RE: Approval with Modifications, Annual Facility Wide Ground Water Monitoring
Report: Gallup Refinery - 2013
EPA ID # NMD000333211, HWB-WRG-14-006

Western Refining, Gallup Refinery has prepared the following responses to the comments in your letter of May 18, 2016 regarding the above referenced report.

Figure 6
FACILITIES AND WELL GROUPS
 WESTERN REFINING - GALLUP REFINERY

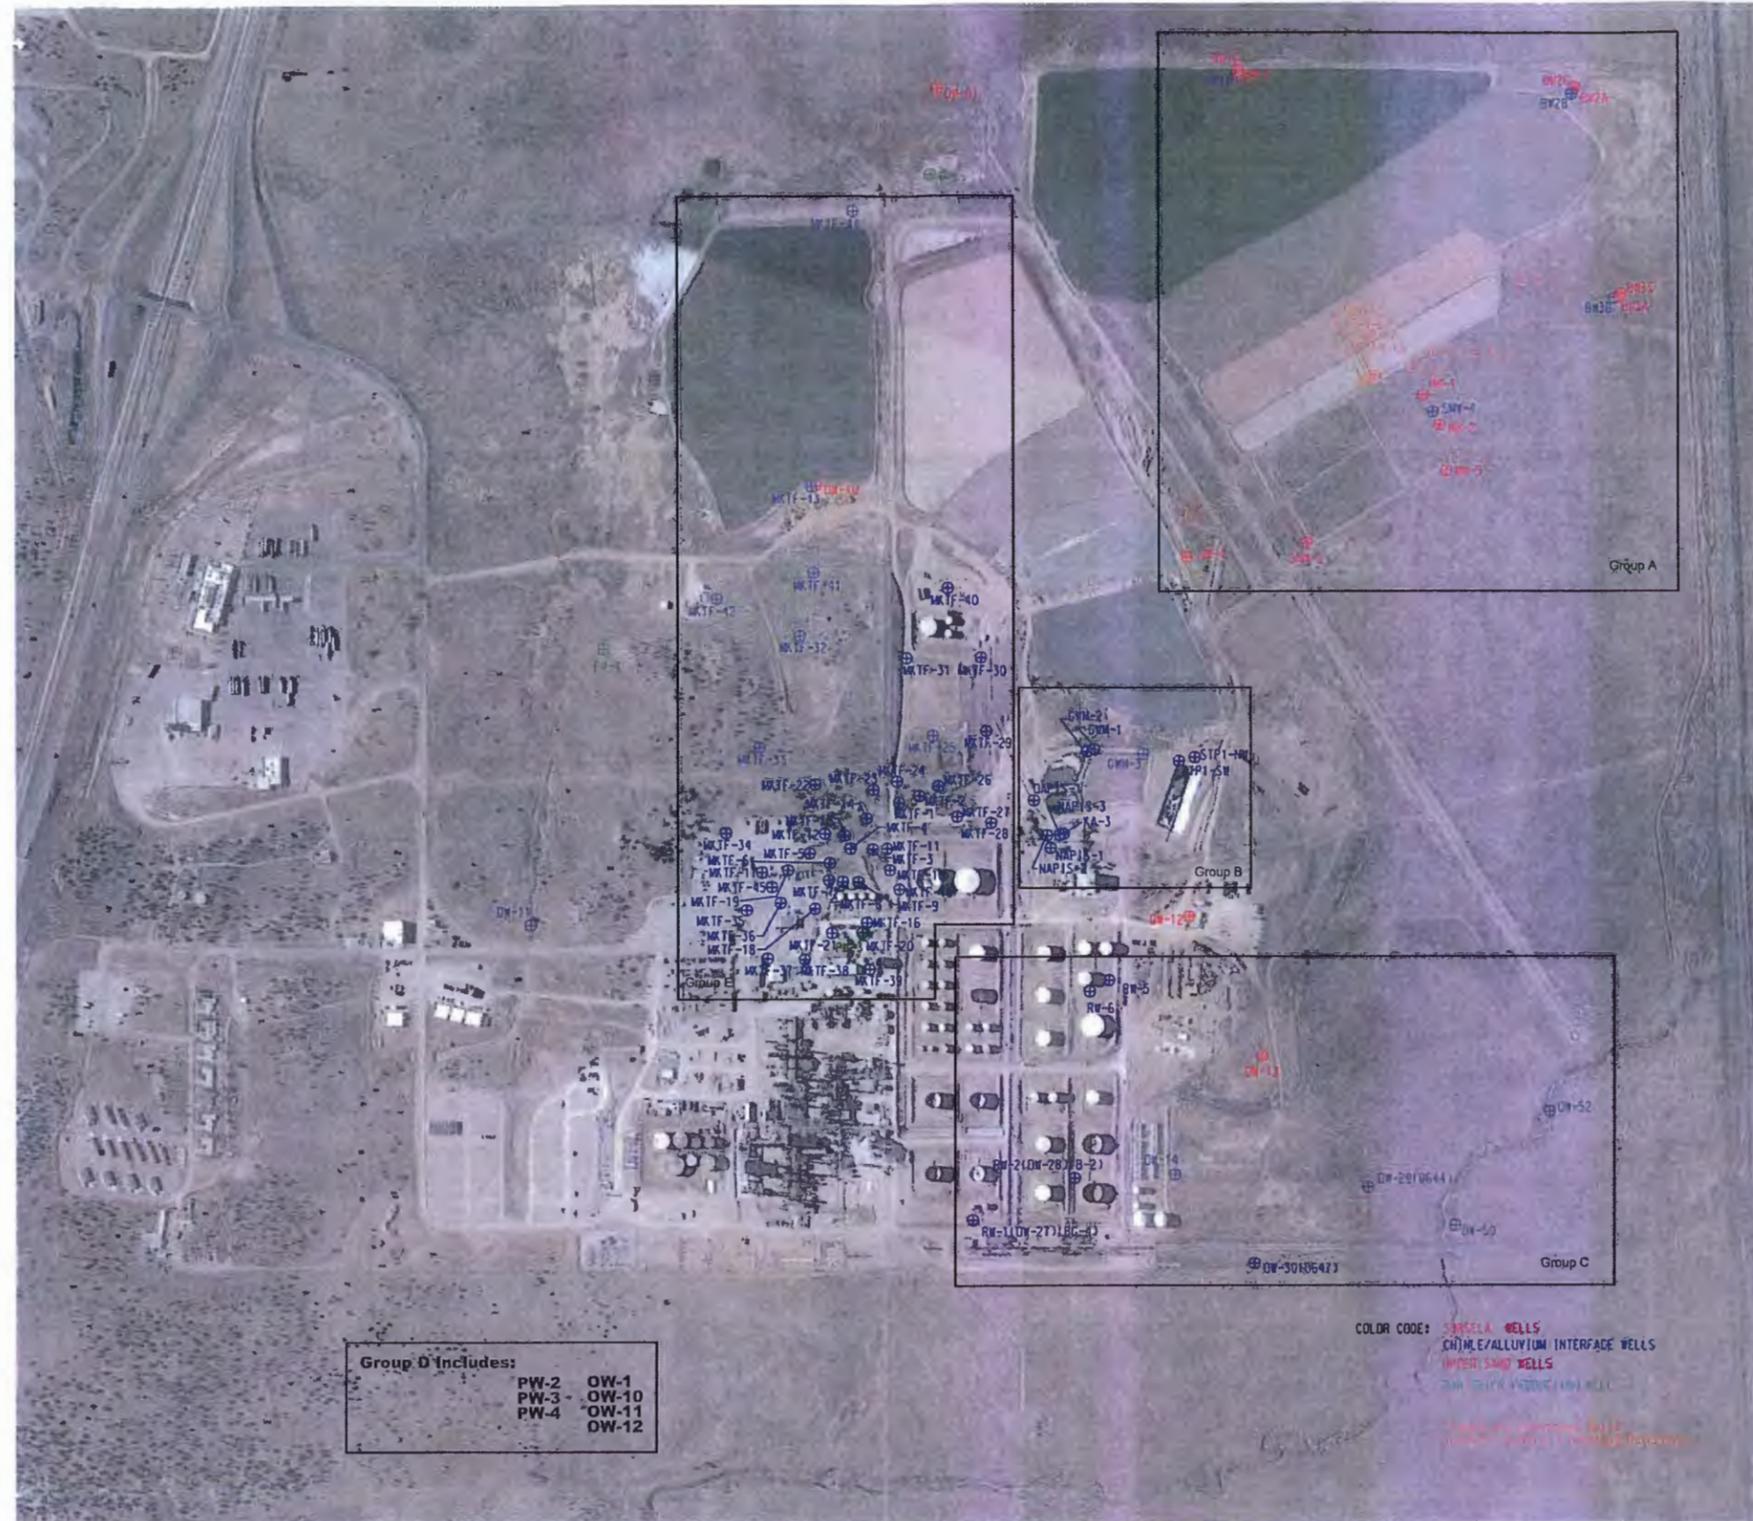
Figure 8(S-N Section Westerly Plant Area) does not correlate to the information provided in Figure 6. For example, wells OW-05 and OW-03 and OW-24 are not shown on Figure 6. Provide updated figures that show the locations of all ground water monitoring wells. If the wells have been abandoned, note this on the figures. Where appropriate, provide replacement figures with the response letter.

***Response:** Figure 6 and Figure 8 have been revised with an explanation that wells OW-05, OW-03 and OW-24 are abandoned/closed wells and were only used for cross section lithology reference points only. (Revised Figures 6 and 8 attached)*
